UNITED STATES PATENT AND TRADEMARK OFFICE

APPLICATION NO.	FILING DATE	FIRST NAMED INVENTOR	ATTORNEY DOCKET NO.	CONFIRMATION NO.
10/700,630	11/05/2003	Satoru Ishikawa	117682	4880
25944	7590	05/06/2005	EXAMINER	
OLIFF & BERRIDGE, PLC P.O. BOX 19928 ALEXANDRIA, VA 22320			CHEN, SOPHIA S	
		ART UNIT		PAPER NUMBER
				2852
DATE MAILED: 05/06/2005

Office Action Summary	Application No.	Applicant(s)	
	10/700,630	ISHIKAWA ET AL.	
	Examiner	Art Unit	
	Sophia S. Chen	2852

DETAILED ACTION

FIG.6

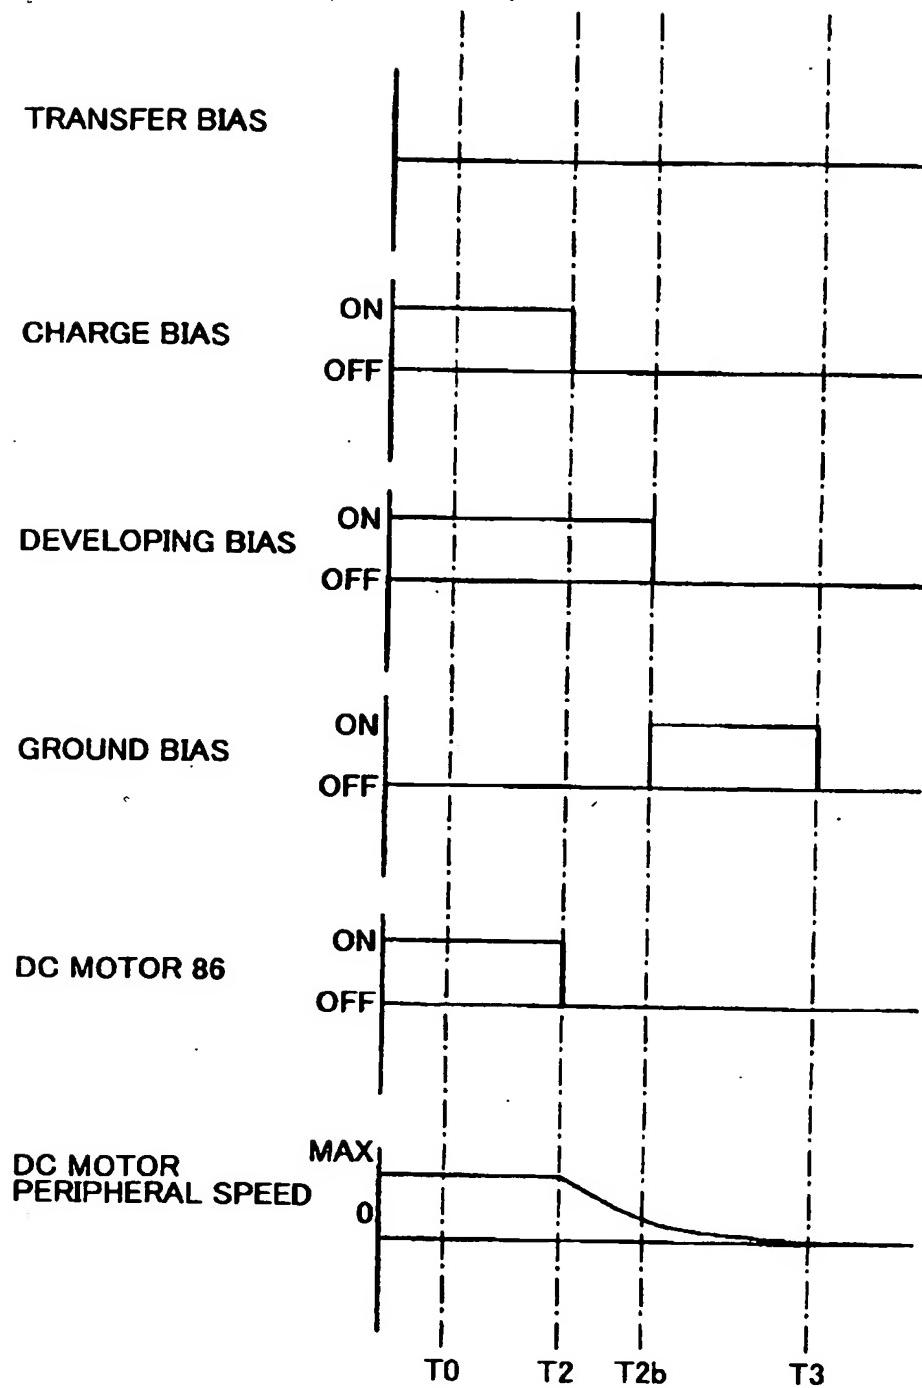
Approved 5/2/05
